Vermont Agency of Transportation
Brattleboro BR 2000 (26) - Bridge Rail Summer_Sharpest_Fit
RECEIVED
ON: May 9, 2016
and Checked for
CONFORMANCE
BY: Jennifer Fitch DATE: 05/18/2016

SHOP DRAWING REVIEW

BRIDGE RAIL DETAILS SHEET

BRATTLEBORO BR 2000 (26)
VERMONT

PLAN VIEW OF A SECTION OF THE WEST RAIL

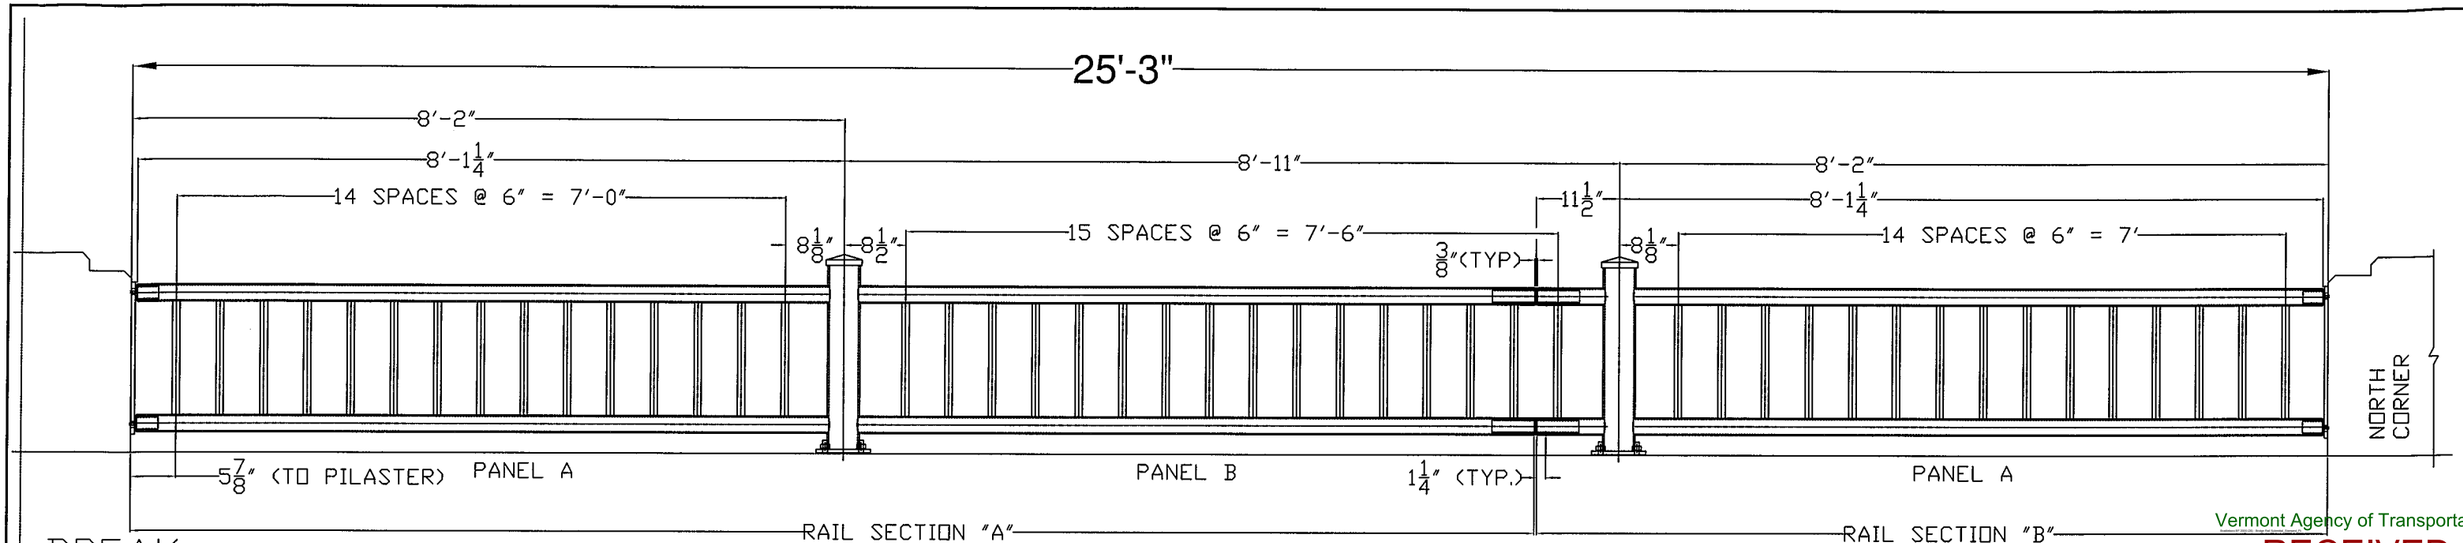
VERIFY CIRCLED QUANTITIES

ARE THE POST BASE PLATES INCLUDED IN THE RAIL SECTIONS? VERIFY INCLUDED IN BOM.

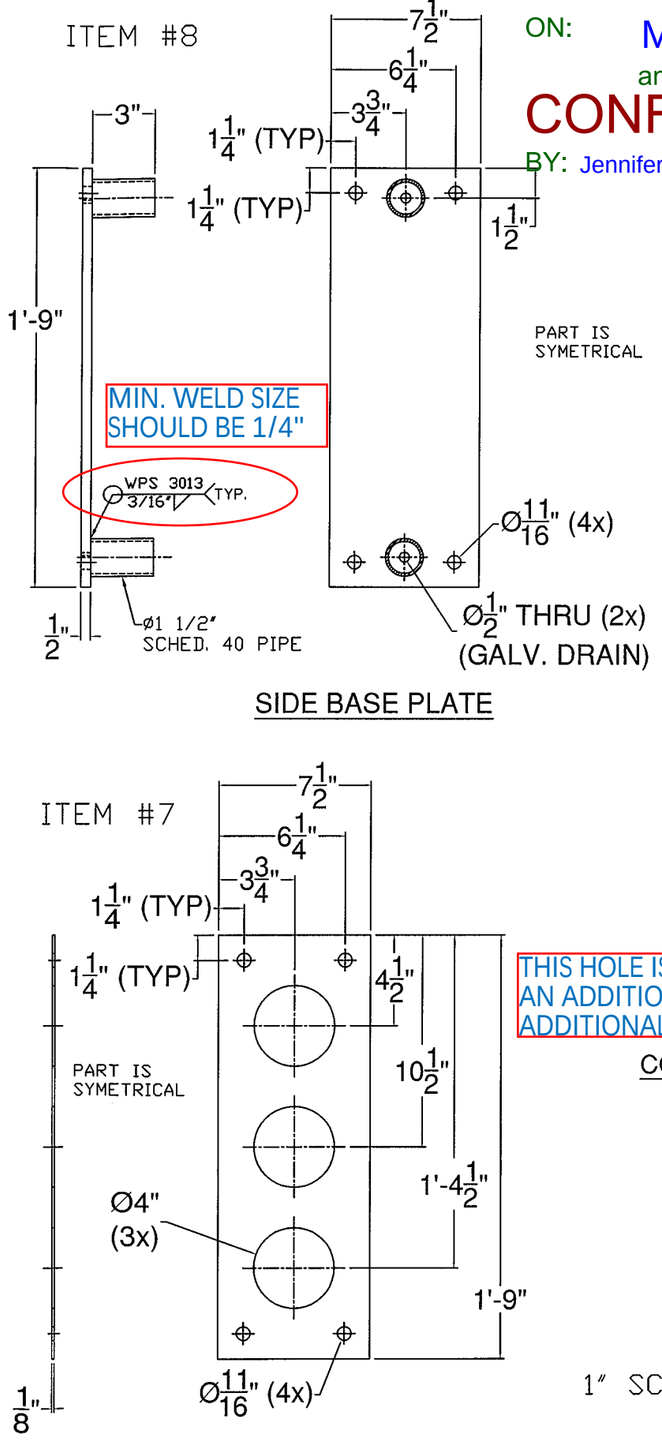
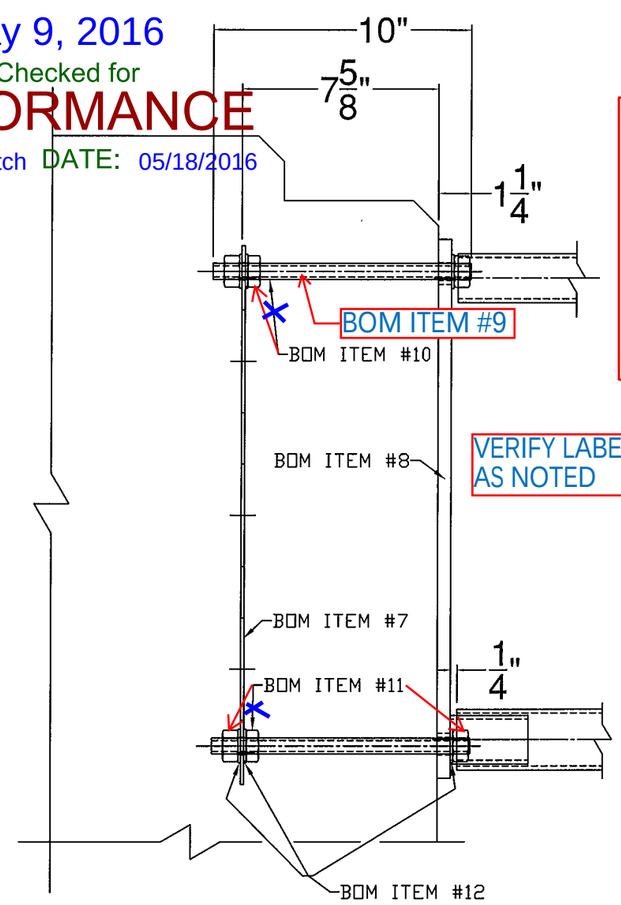
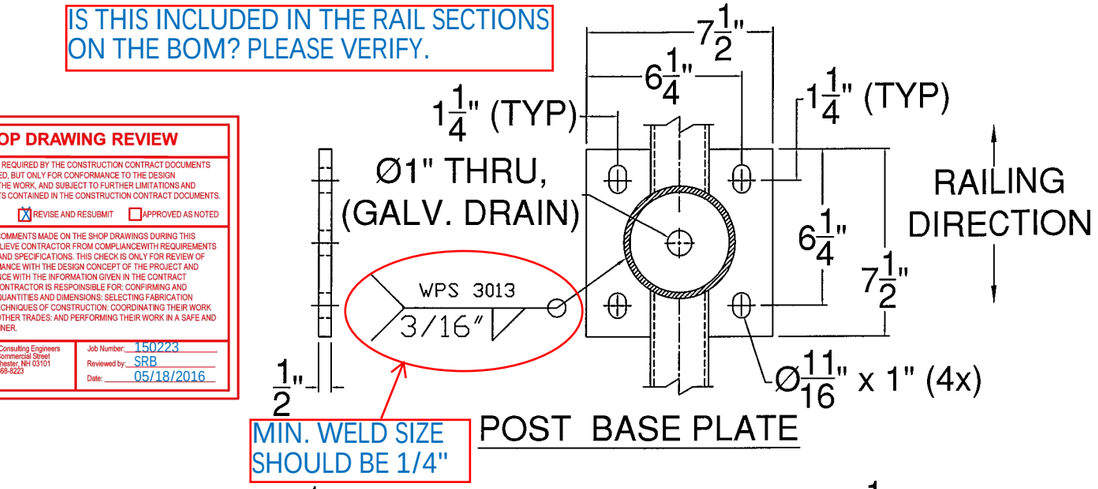
IS THIS INCLUDED IN THE RAIL SECTIONS ON THE BOM? PLEASE VERIFY.

CONNECTION PLATE DETAIL

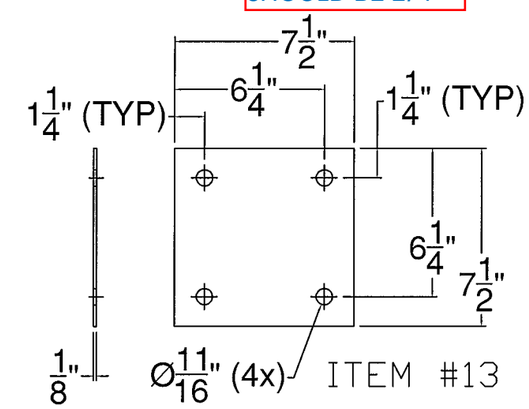
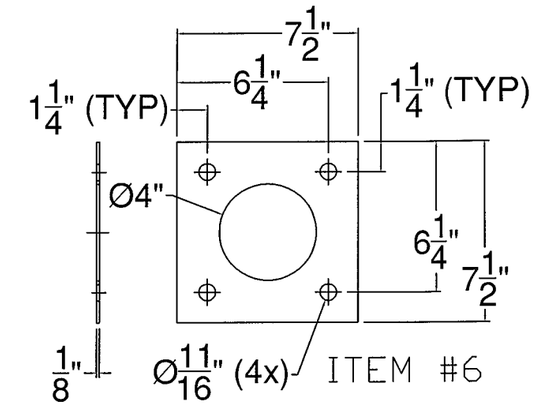
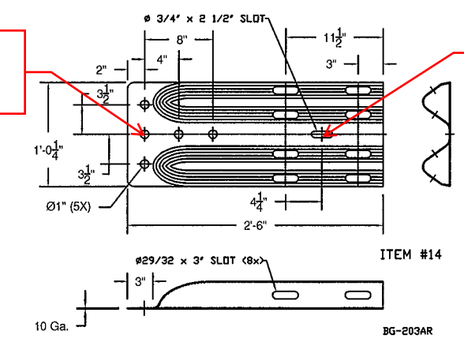
THIS HOLE IS NOT SHOWN ON CONTRACT PLANS, AND THE BOM DOES NOT APPEAR TO INCLUDE AN ADDITIONAL BOLT TO ACCOUNT FOR THIS HOLE. EITHER REMOVE ADDITIONAL HOLE OR ADD ADDITIONAL BOLT.

THE BOM DOES NOT APPEAR TO INCLUDE A BOLT FOR THIS HOLE.

WELDING PROCEDURE SPECIFICATION

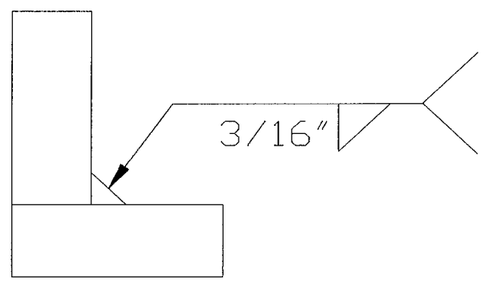
ALTHOUGH THIS IS HANDRAIL, AS IT IS PART OF THE BRIDGE RAIL, IT SHOULD BE FABRICATED PER D1.5 AND HAVE THE SUPPORTING PQR INCLUDED WITH THE SUBMITTAL. PLEASE REVISE.

WELDING PROCEDURE SPECIFICATION

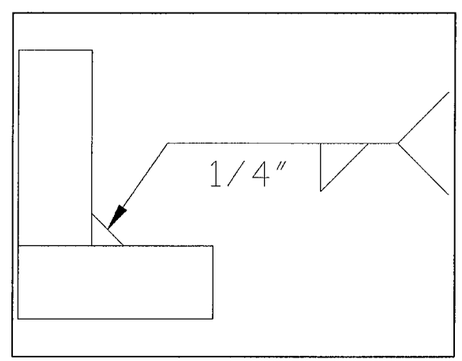
ALTHOUGH THIS IS HANDRAIL, AS IT IS PART OF THE BRIDGE RAIL, IT SHOULD BE FABRICATED PER D1.5 AND HAVE THE SUPPORTING PQR INCLUDED WITH THE SUBMITTAL. PLEASE REVISE.
